# Comhairle Chontae Atha Cliath Theas

## Record of Executive Business and Chief Executive's Order

**Reg. Reference:** SDZ22A/0005      **Application Date:** 14-Apr-2022  
**Submission Type:** Additional      **Registration Date:** 09-Sep-2022  
Information

**Proposed Development:** Phase Three of the Adamstown District Centre and consists of 37,402sq.m (gross floor area including car parking and storage) of residential development to be constructed in 3 blocks ranging in height from 2 to 9 storeys; There is a total of 436 apartments, comprising 9 studio apartments, 204 one bedroom apartments, 213 two bedroom apartments and 10 three bedroom apartment; An ancillary resident's pavilion building (2 storey) is linked to Block D, ancillary resident's amenity rooms and facilities are also provided at ground floor level of Block A; All apartments are provided with private open space in the form of balconies or gardens; The proposed block description is as follows: Block A (c. 11,821sq.m gross floor area): 4 - 5 storeys in height, with a total of 143 apartments (70 one bedroom apartments, 67 two bedroom 4 person apartments and 6 no. 3-bedroom apartments); A resident's only podium level,

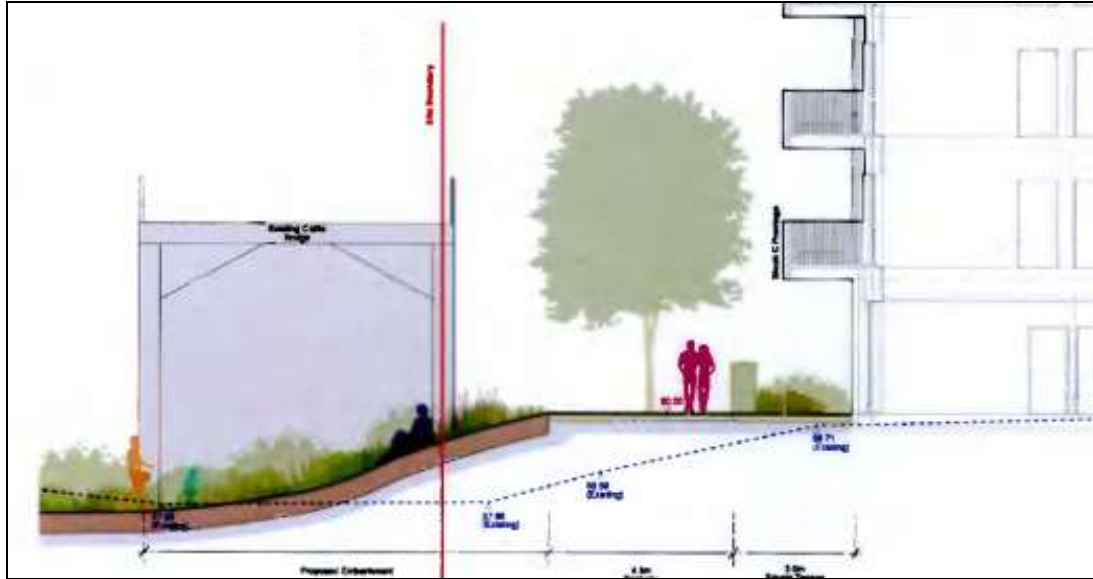
Section 4.3 of the Design Statement sets out that there is a Pedestrian and Cycle route along the existing Bridge. Page 29 states that 'Bridge Walk' – "*own door units accessed from the proposed*

*pedestrian route along the cattle bridge at the Western edge provide activity and passive surveillance to this area”.*

Given the bridge's location outside the redline, it is considered that the interface with the adjacent bridge has been considered in sufficient detail. Further consideration of the finish and upgrade of the bridge will be considered in future planning application in the adjacent Development Area.

Figure 3 Cross section of West Street.

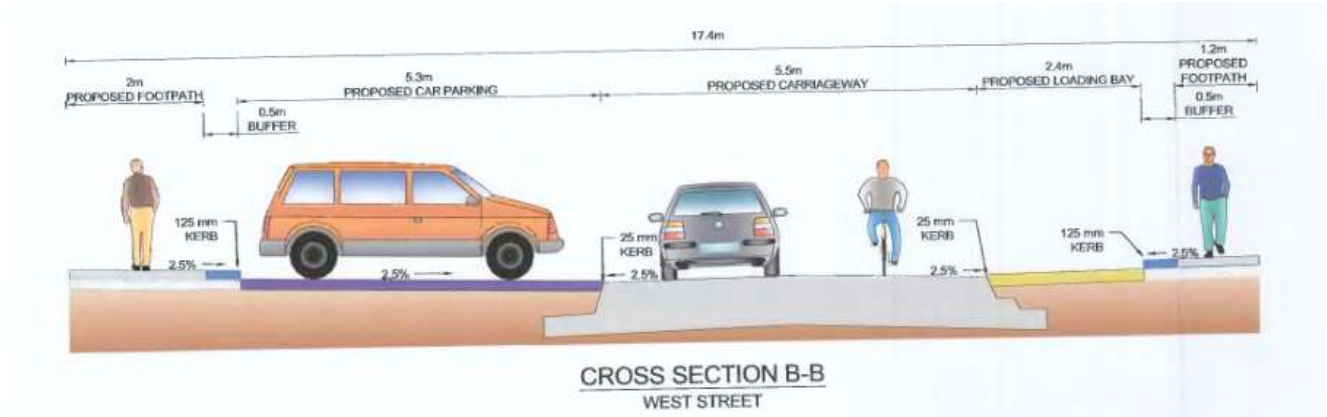
The submitted cross section of West Street shown in Figure 3 detail the footpath width at 1.2m this must be 2.0m at a minimum.
